ADDENDUM NO. 2

JUNE 8, 2017

**Tucson Airport Authority
Tucson International Airport
10112-254 Rehabilitate Runway 11L-29R and Connector Taxiways**

QUESTIONS/CLARIFICATIONS RECEIVED FOR PROSPECTIVE BIDDERS:

SHEET REFERENCE NUMBER: E204
SHEET 279 OF 410

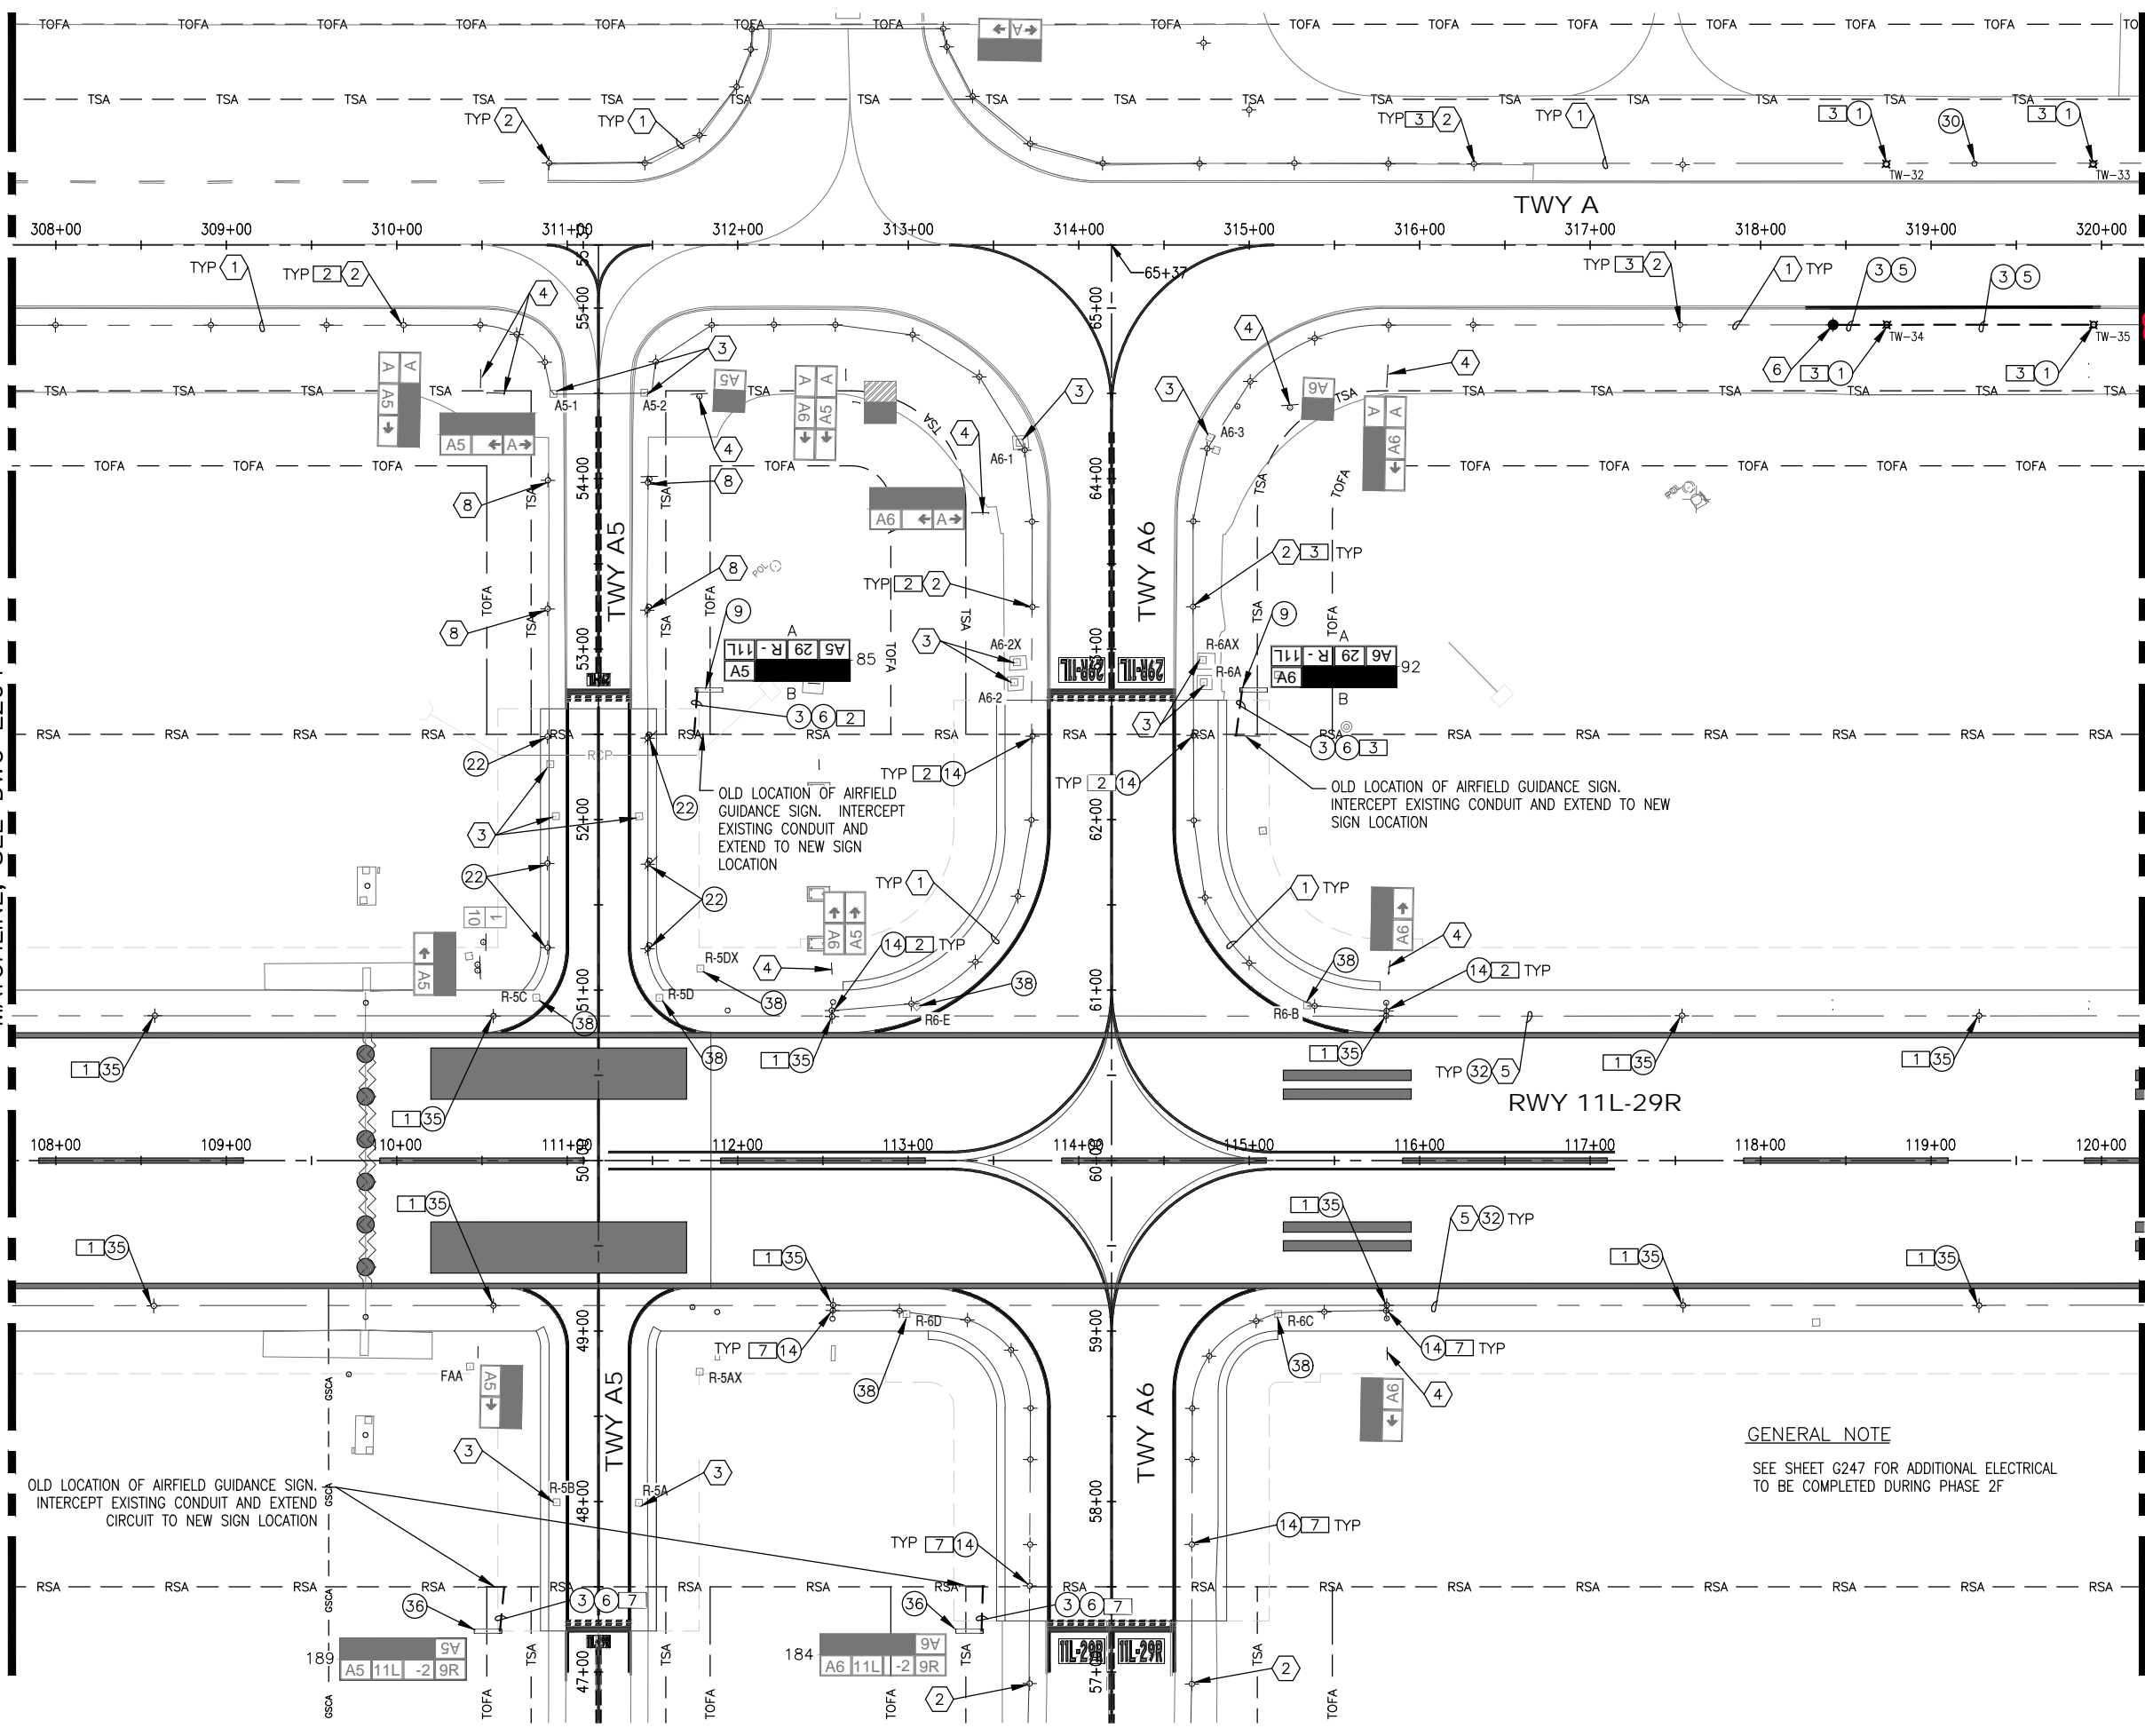
- 7.) Drawing E204, note 16 shows an existing airfield guidance sign with new panels. Where in the bid schedule are the panels to be included?

- 8.) Drawing E204, where in the bid schedule are the materials for note 25 need to be included?
